PERMIT
 SEWAGE DISPOSAL SYSTEM
 MARYLAND STATE DEPARTMENT OF HEALTH
 HOWARD COUNTY

P 20327
 A 14103
 ELLICOTT CITY
 DISTRICT 3rd
 DATE 7/10/74

SUBDIVISION Benson ROAD 3506 Lakeway Drive LOT 2, Blk. B, Sec. 1

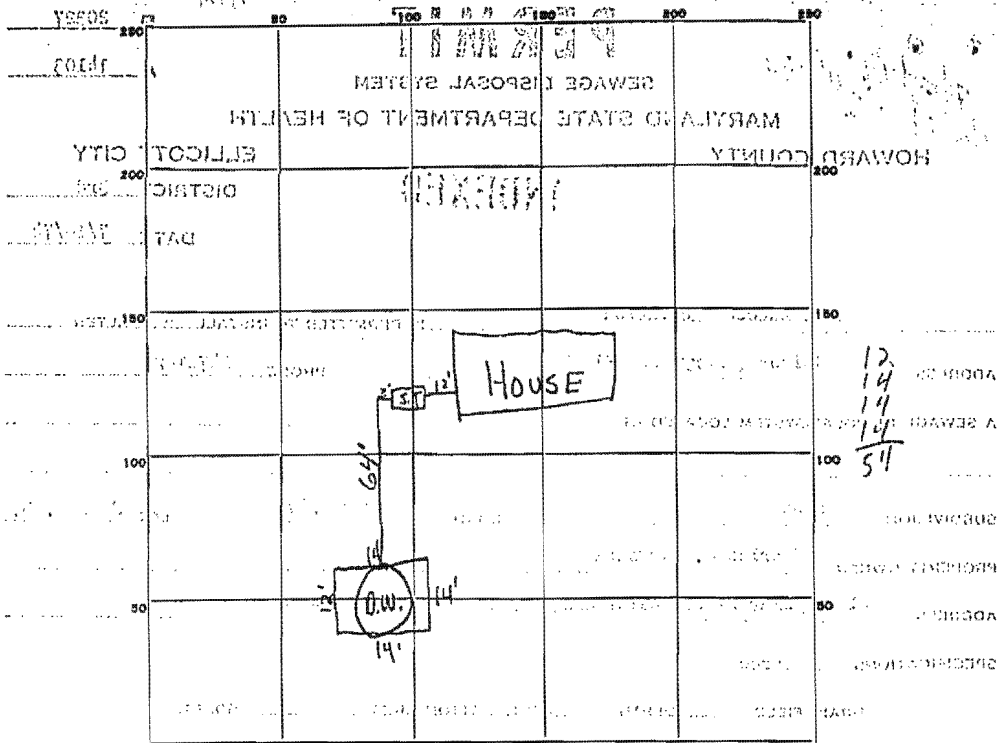
REMARKS: 7/12/74 No expansion well; pipe from house to septic tank not exposed. D.W. well inlet is at 25' below original grade. Partial checkout only A.S.

9/6/74 House sewer pipe from house to tank now exposed; cap on D.W. cleanout A.S.
